**DEPARTMENT OF TRANSPORTATION
STATE OF GEORGIA**

Project number: STP-8042(9)

Description: I-185 @ Buena Vista Road Interchange

INITIAL CONCEPT TEAM MEETING
MEETING MINUTES
Buena Vista Road from I-185 to Dogwood Drive
STP-8042(9), P.I. No. 351190, Muscogee County

TYPICAL SECTIONS
EXIT AND ENTRANCE RAMPS
TYPICAL SECTIONS
NOT TO SCALE

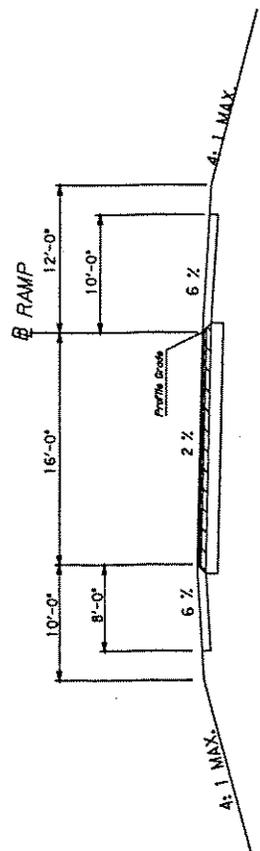
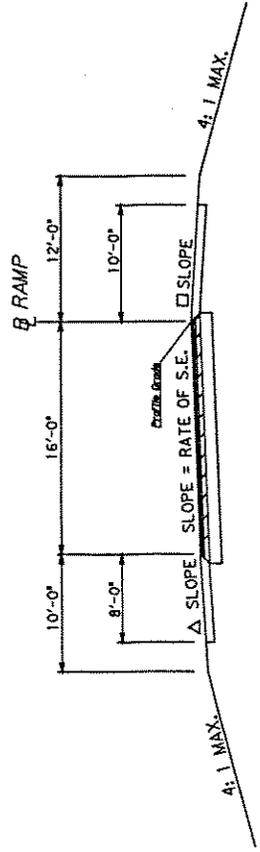
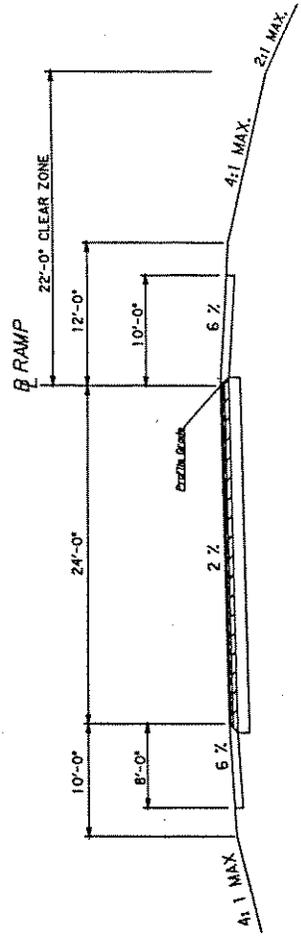
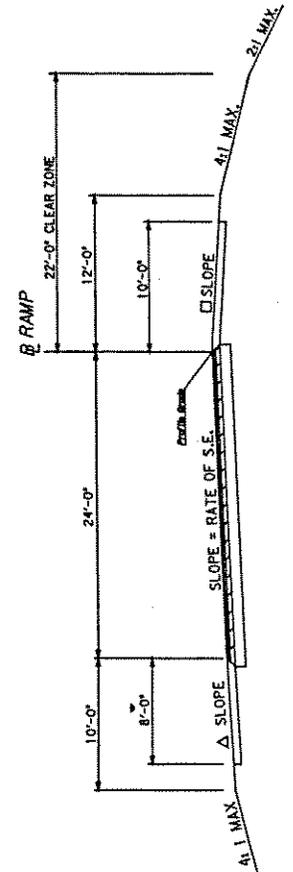
- David Painter of FHWA stated that parallel exit ramps rather than tapered should be used. PBS&J will revise the concept to include the parallel design for the SB and NB exit ramps.
- Graded shoulders should be used on all ramps. An existing curb and gutter on the ramps should be removed as part of the project. V-gutters can be used to handle any run-off that was being collected in the existing curb and gutter.

Exit ramps from I-185 – Single lane parallel type exit ramps that widen to three – 12’ turn lanes at Buena Vista Road. Inside graded shoulders are 10’ total width with 8’ paved, and outside graded shoulders are 12’ total width with 10’ paved. Guardrail, side barriers and “v” gutter to be constructed where appropriate.

BUENA VISTA ROAD
 INTERCHANGE CONCEPT

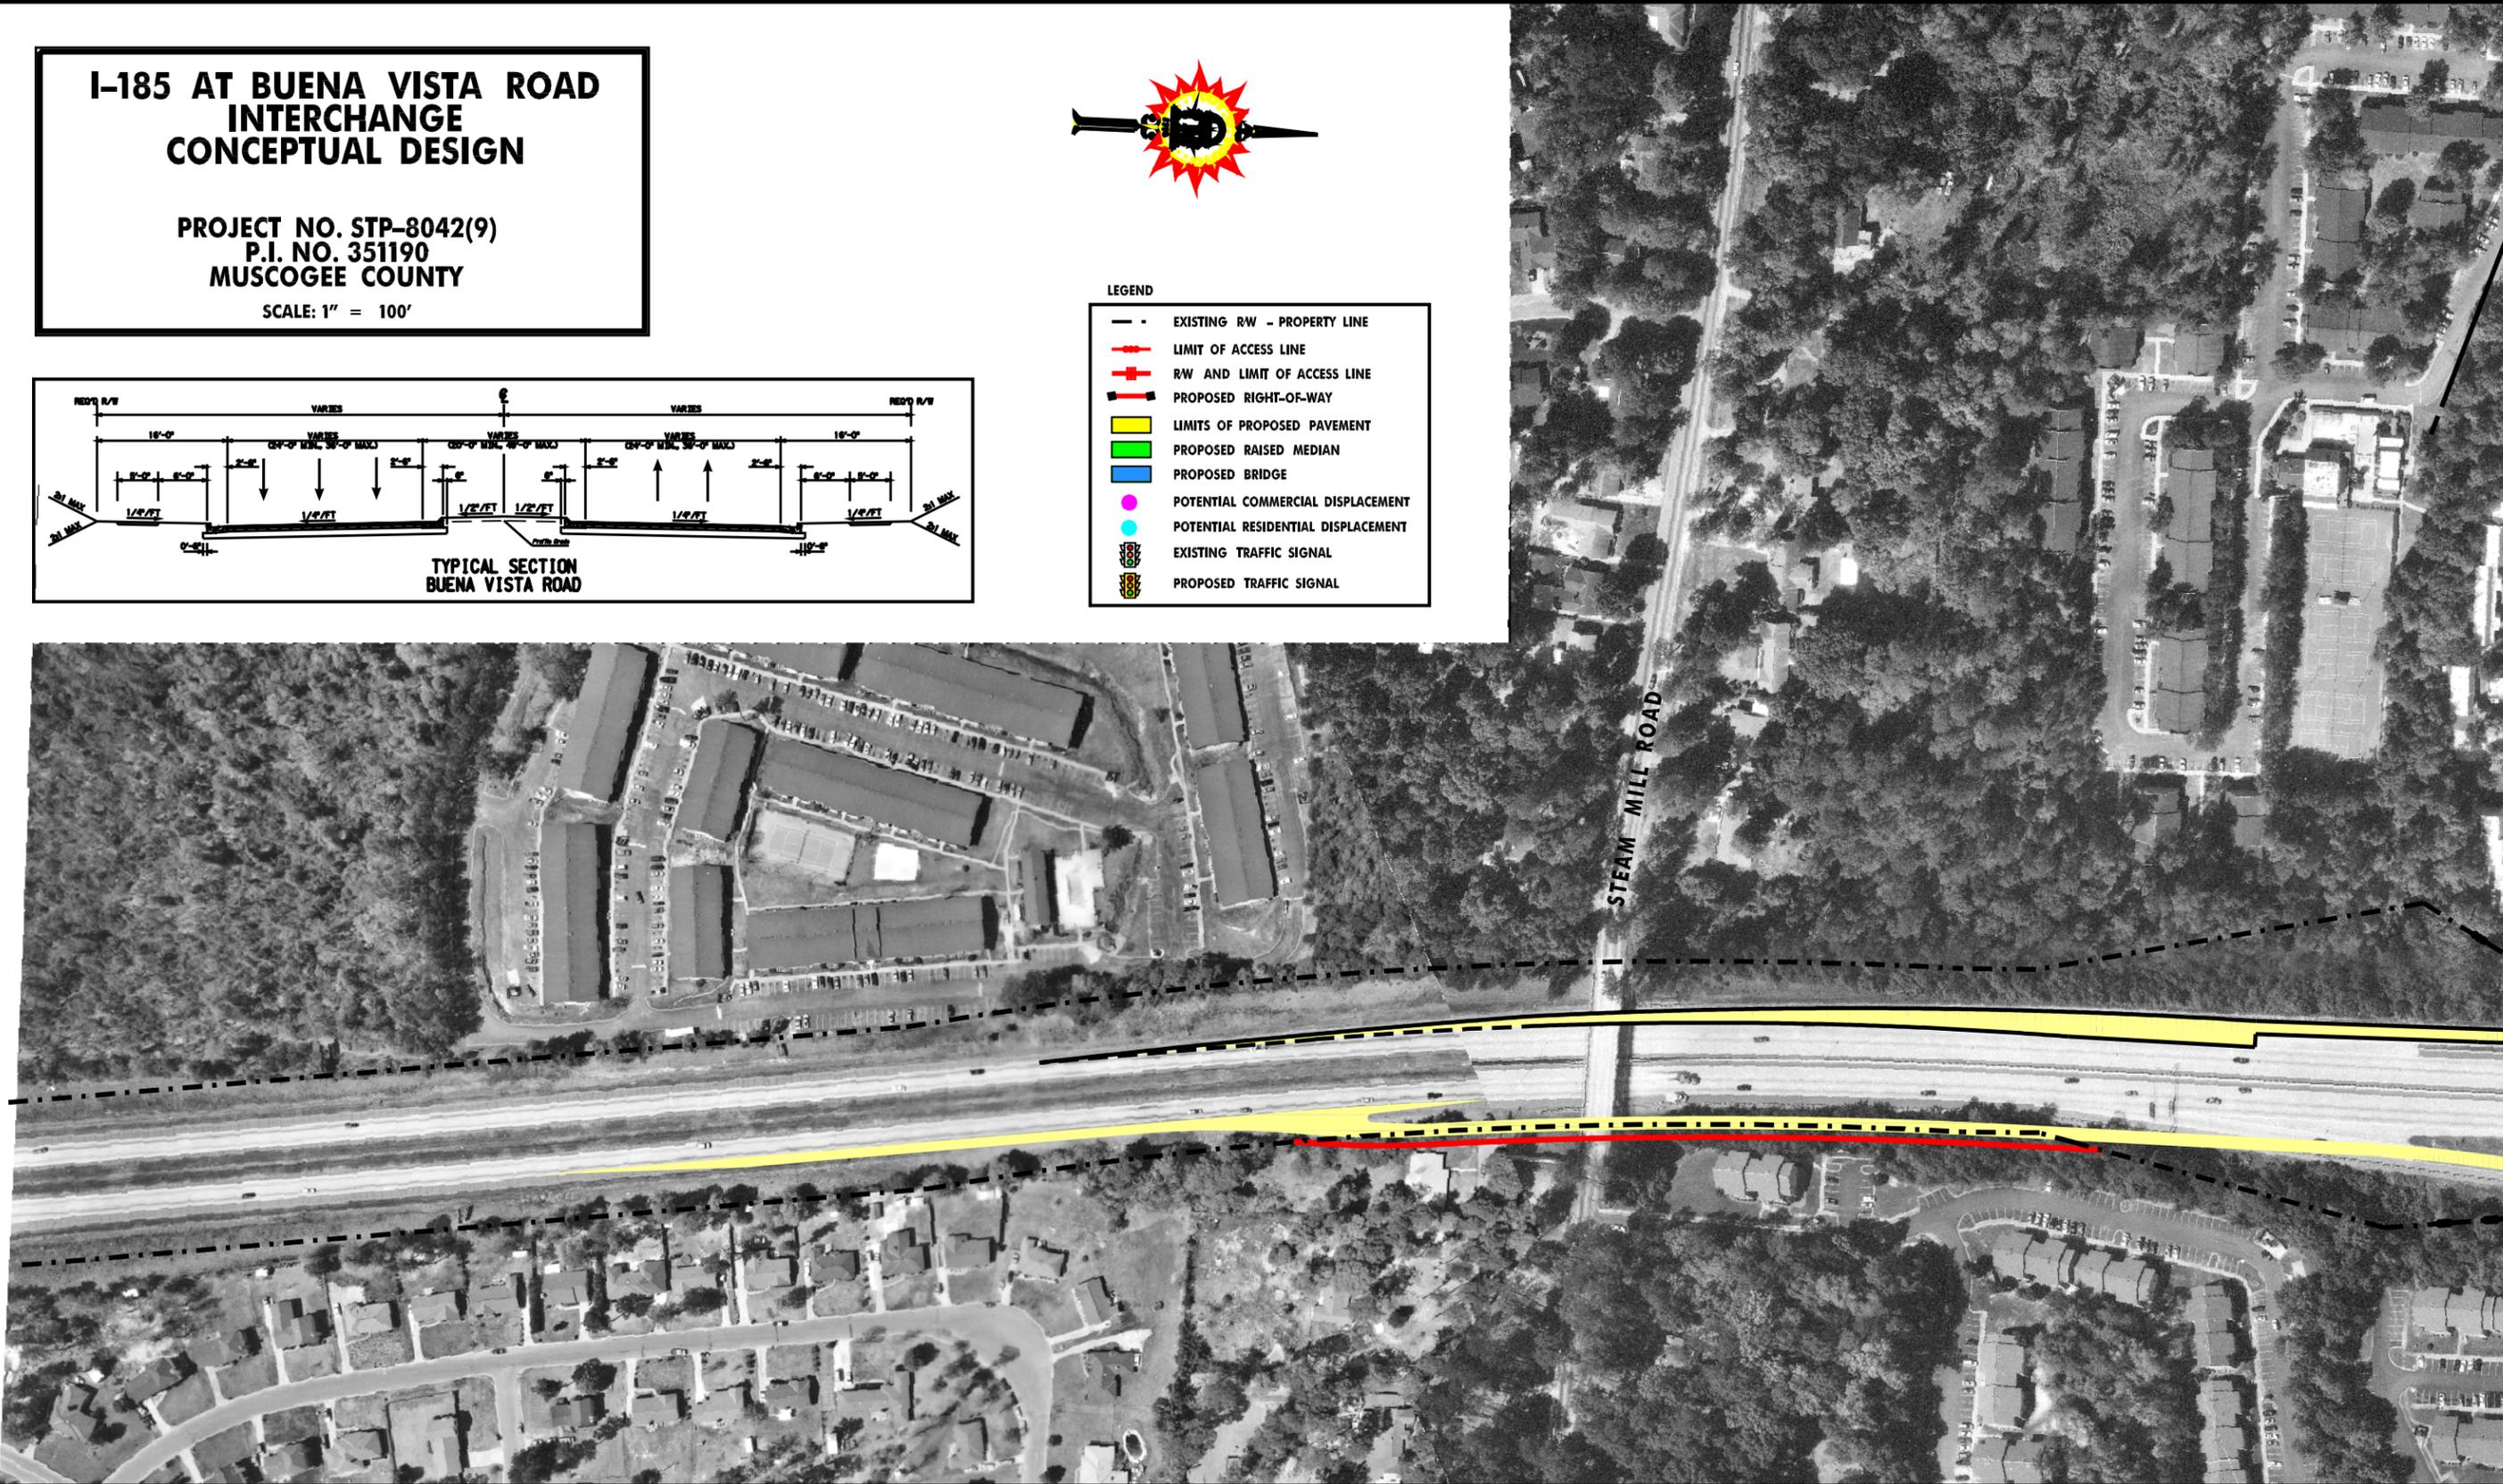
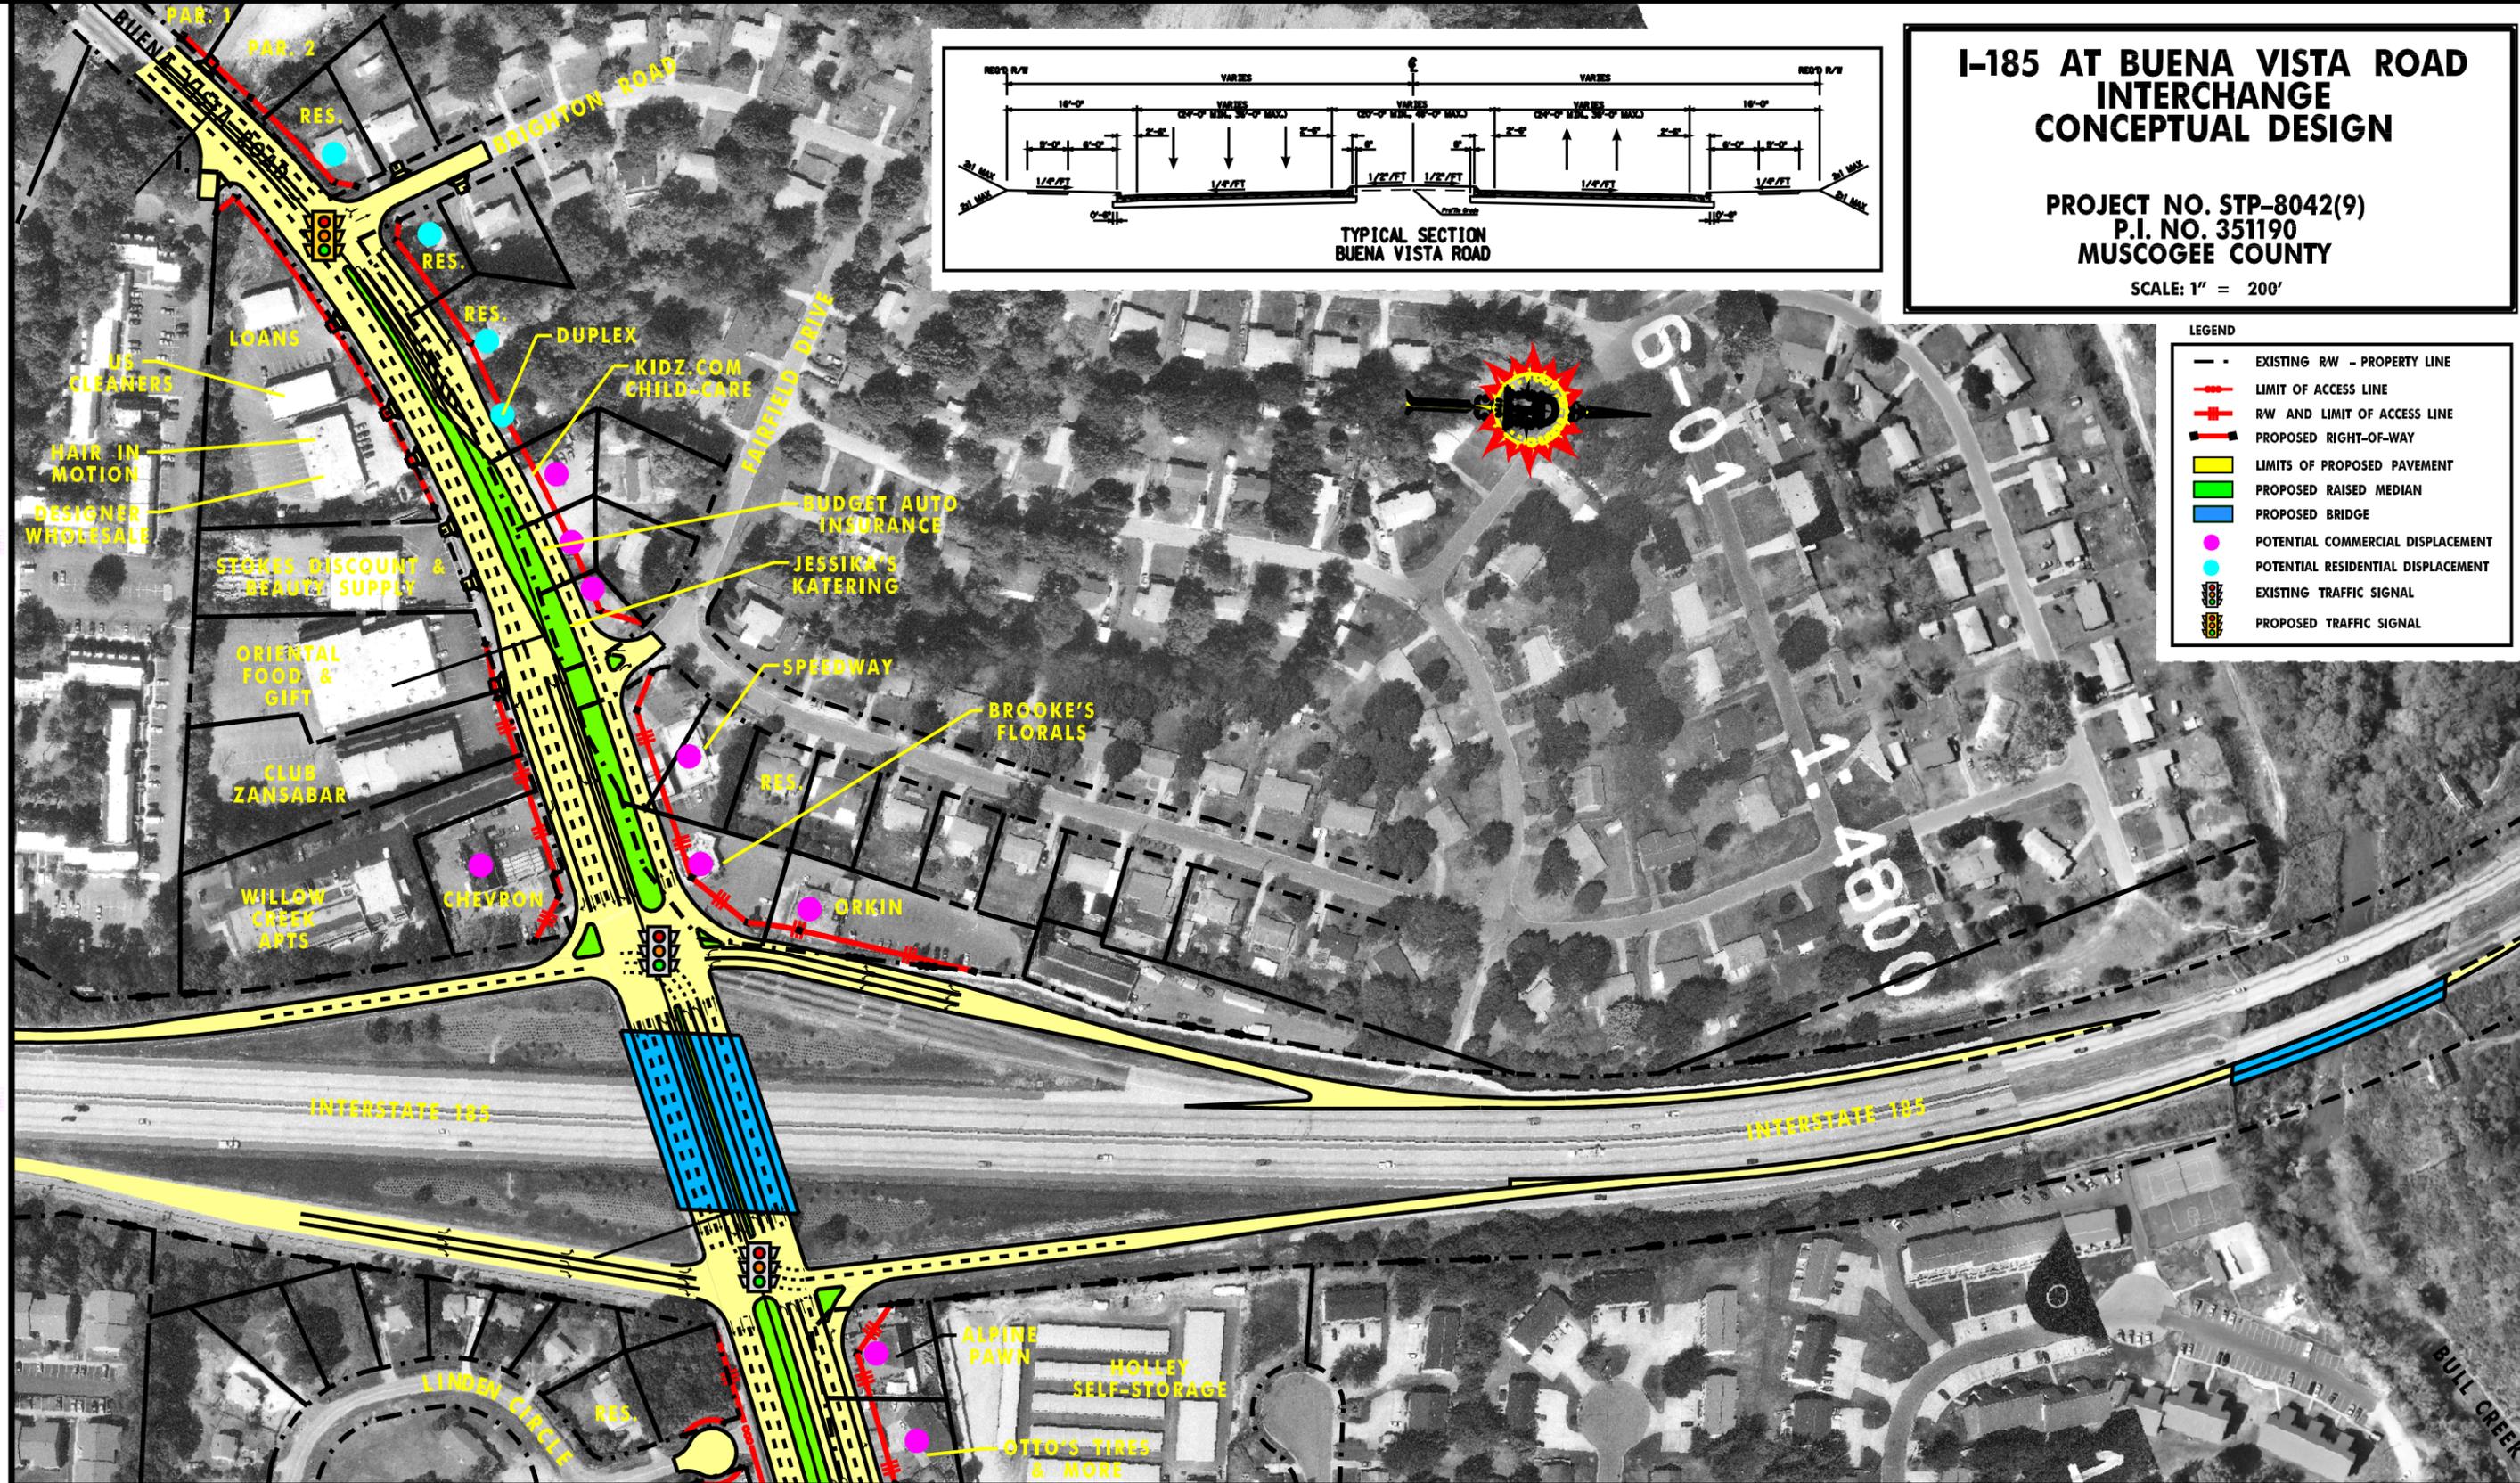
- The proposed traffic signals should be interconnected with underground rather than overhead fiber. There is no local TMC.
- The third EB through lane should be carried through Linden Circle at the Mall Entrance, and then tapered back into the mainline. PBS&J will revise the concept accordingly. The lane taper should be a minimum of 245' long, but longer is desirable.

- Scott Zehngraft of GDOT Traffic Safety and Design questioned the use of dual rights at the intersection of the NB exit ramp with Buena Vista Road. He asked whether a dual left /right center lane would operate more efficiently. PBS&J will verify.

- Scott Zehngraft of GDOT Traffic Safety and Design questioned the proposed storage lengths of turn lanes on the I-185 exit ramps. It was noted that the proposed storage lengths are roughly the same as the existing storage lengths. PBS&J will verify the recommendations. PBS&J will also analyze the storage lengths using HCS in addition to Corsim.

- Scott Zehngraff at the Department also questioned the proposed turn-bay lengths for the exit-ramps and thought that they should be longer. The proposed turn-bay lengths are adequate and result in an acceptable LOS for those approaches under future design hour conditions. Theoretically, there is no problem with lengthening the turn-bay lengths on the exit-ramps (i.e. it would not hurt operations) but there would need to be criteria other than acceptable LOS provided in order to justify that the turn-bays were long enough. The reason that the turn-bay lengths on the ramps were not lengthened is that the improvements on Buena Vista Road will provide more capacity at the intersections with the ramps, eliminating the need to provide more capacity on the exit-ramps themselves. It was also suggested that HCS be used to analyze storage bay lengths. HCS does not model turn-bay lengths. HCS only takes into consideration that there is a turn-bay but it does not care how long the turn-bay is. Moreover, HCS, or any other non-simulation program, would not be capable of analyzing the proper traffic operations of closely spaced intersections such as these two intersections with the I-185 exit ramps. CORSIM is best suited to analyze the traffic operations of such a situation.
